**MUDDY RUN II STREAM AND WETLAND RESTORATION  
PROJECT  
MONITORING REPORT  
MONITORING YEAR 4  
FINAL**

DUPLIN COUNTY, NORTH CAROLINA  
CONTRACT No. 004631 - PROJECT No. 95354

RE: Muddy Run II Stream and Wetland Restoration Site: MY4 Monitoring Report  
(NCDMS ID 95354)

Listed below are comments provided by DMS on January 17, 2018 regarding the Muddy Run II Stream and Wetland Restoration Site: Year 4 Monitoring Report and RES' responses.

- Yes
- No

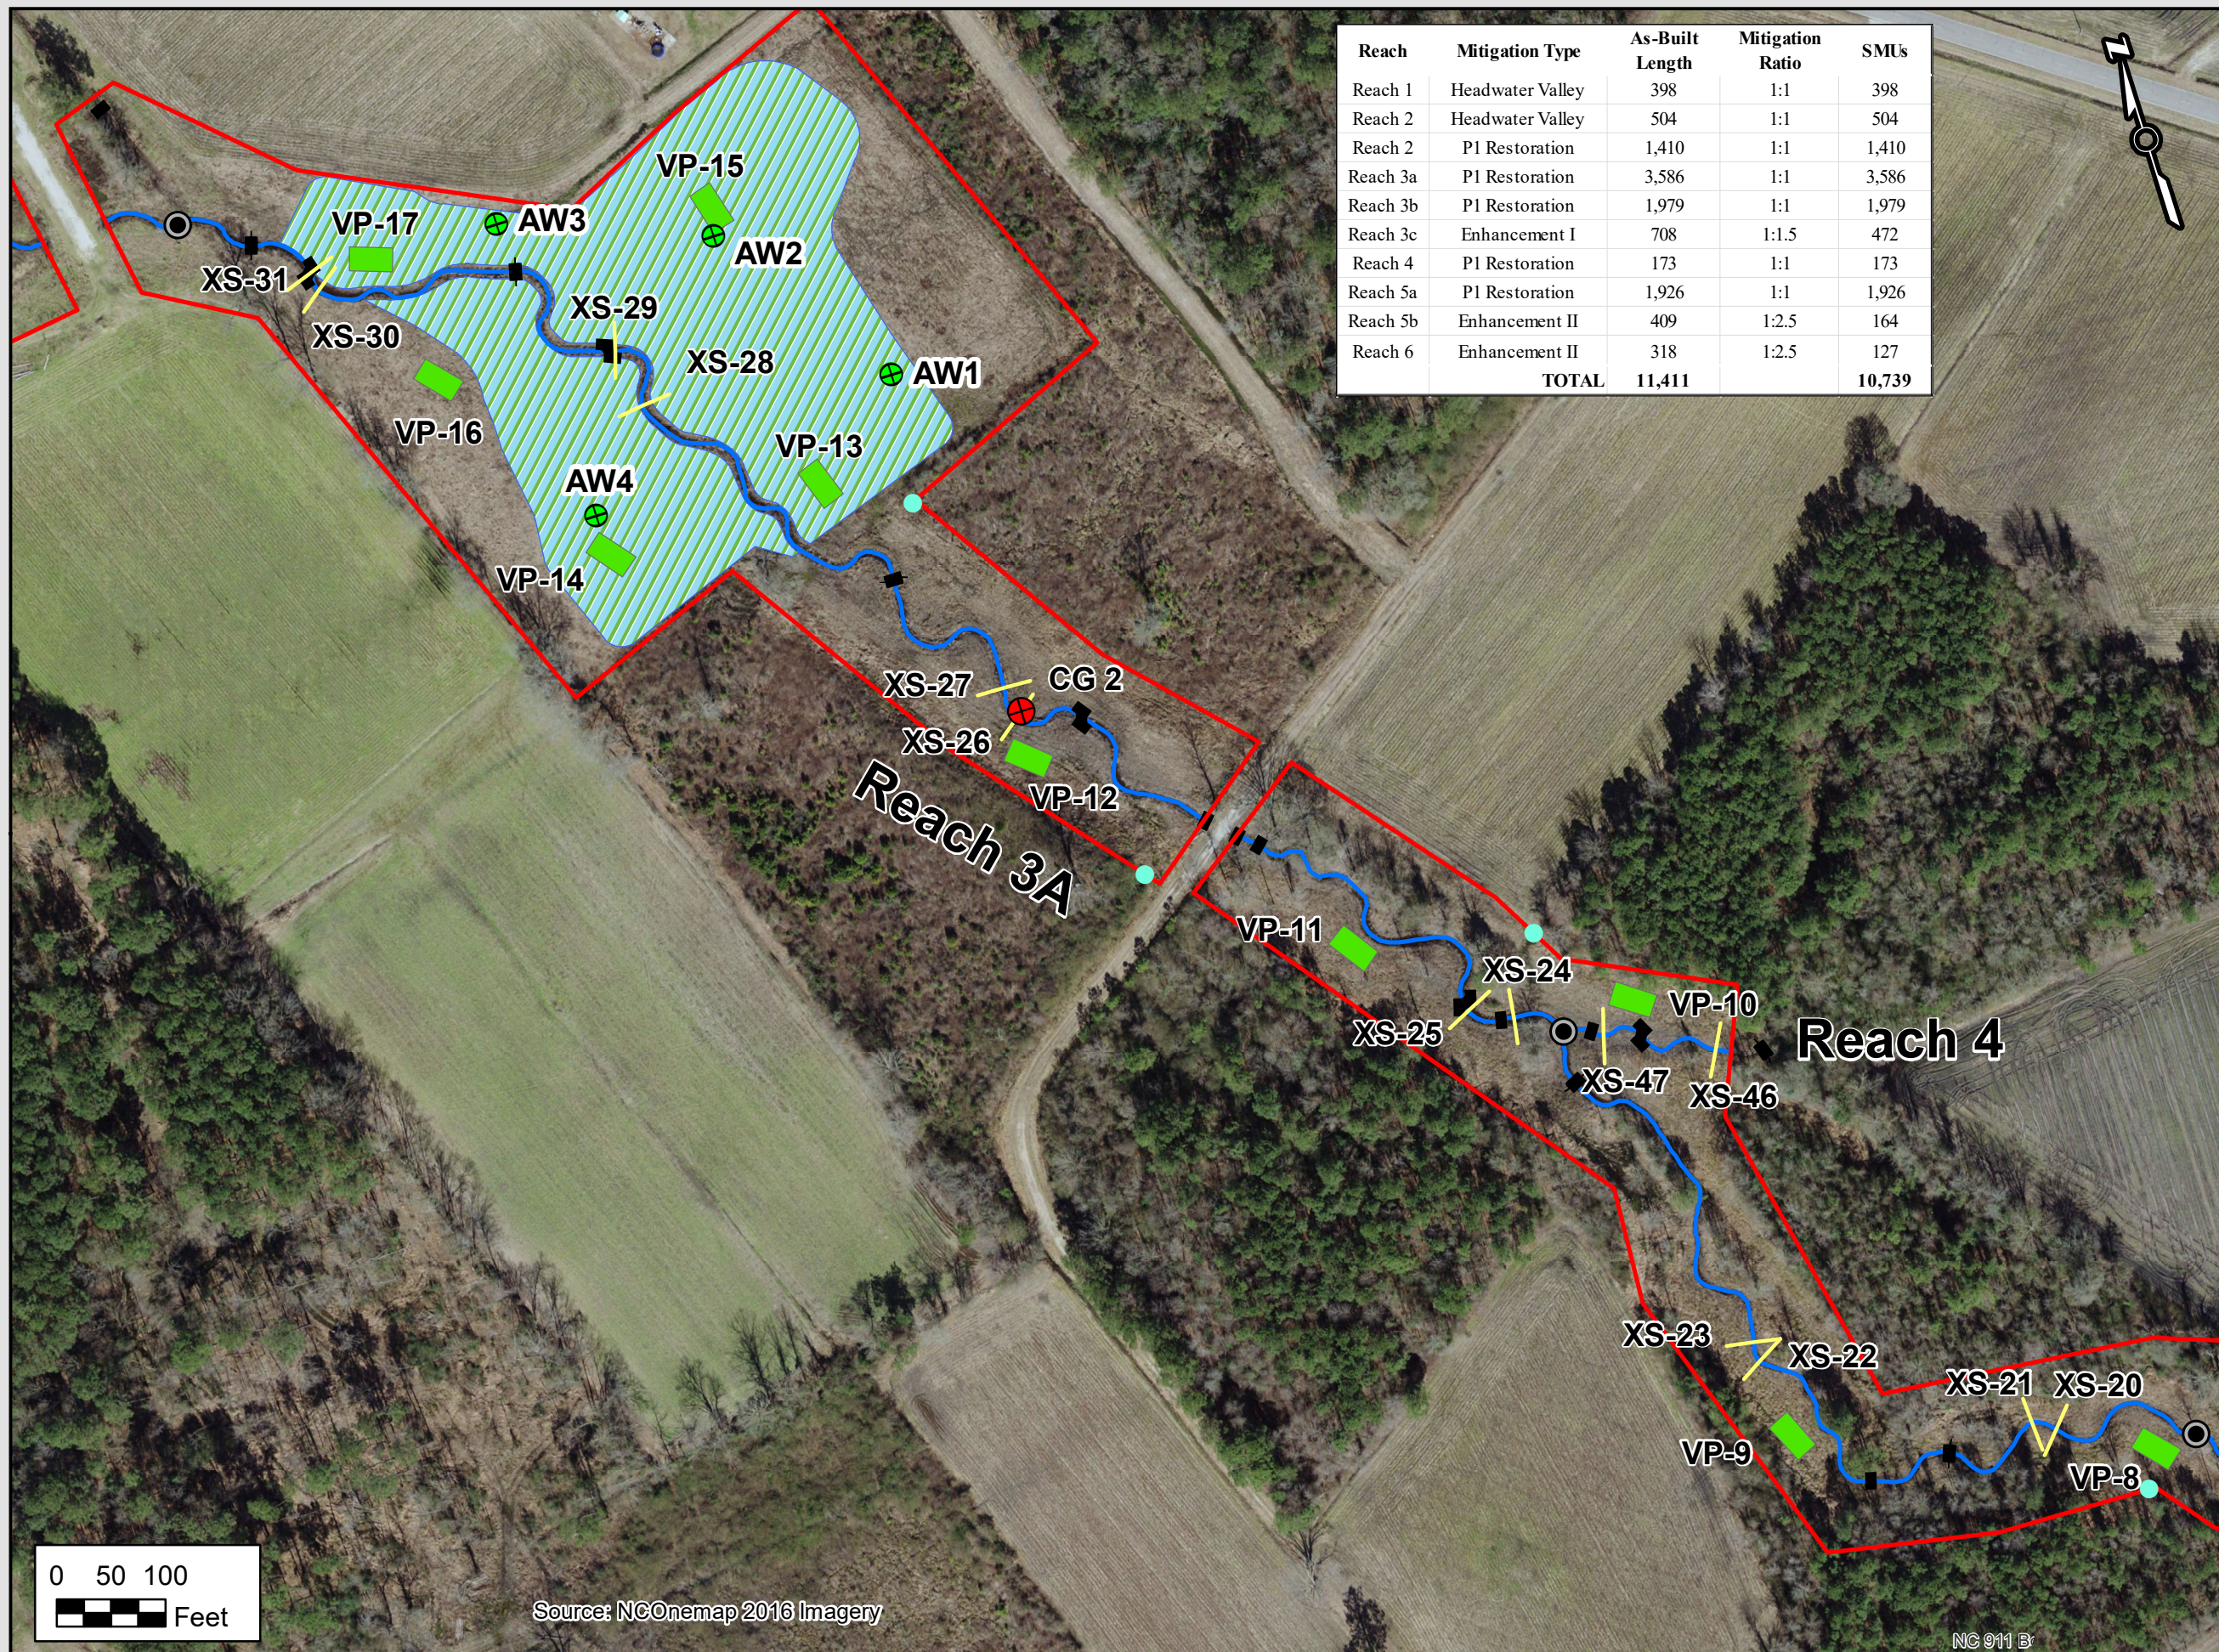
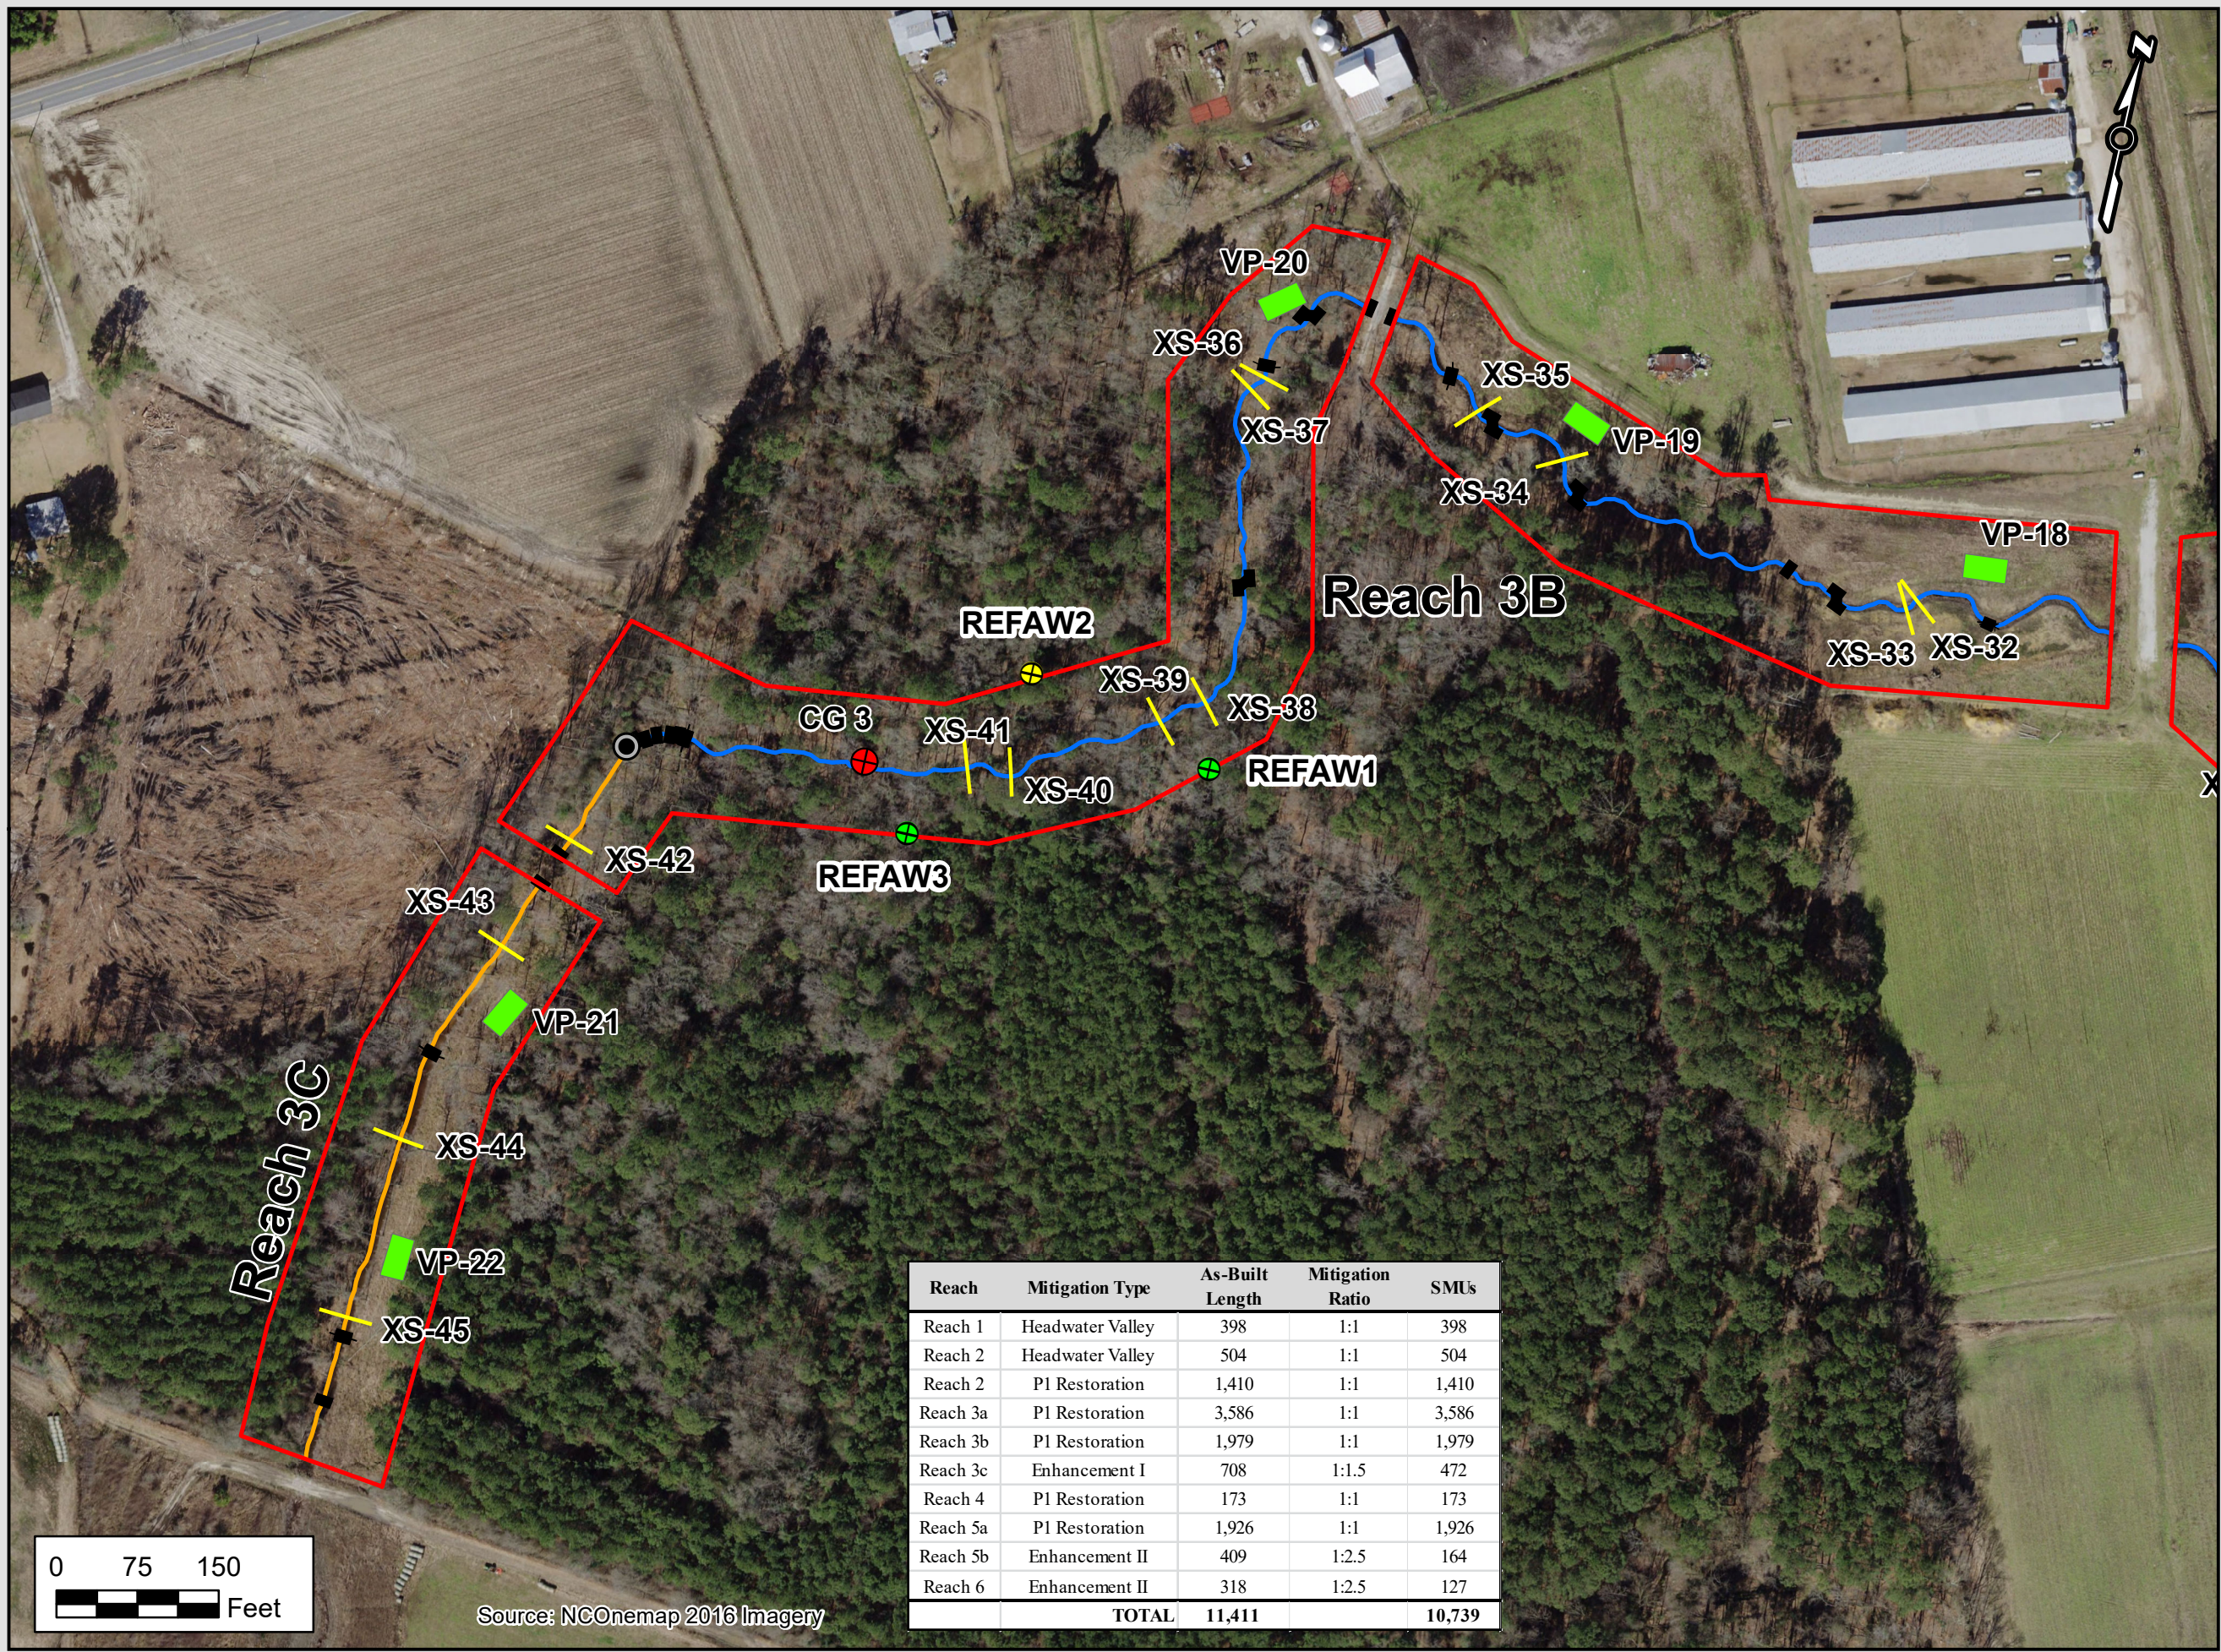
- b. Reach 6 credit: the map shows the upper portion of reach 6 as having EII credit, but the Mitigation plan shows this as a non-credit area. I think you could list the upper portion of this reach and the side channel as additional stream, not for credit. Please update CCPV.

The upper portion of Reach 6 (893 ft) and the side channel (307 ft) that confluences with it are now shown as “Channel – No Credit” on the CCPV and a footnote about them has been added to Table 1. Reach 6 is also discussed in Section 1.3.1.
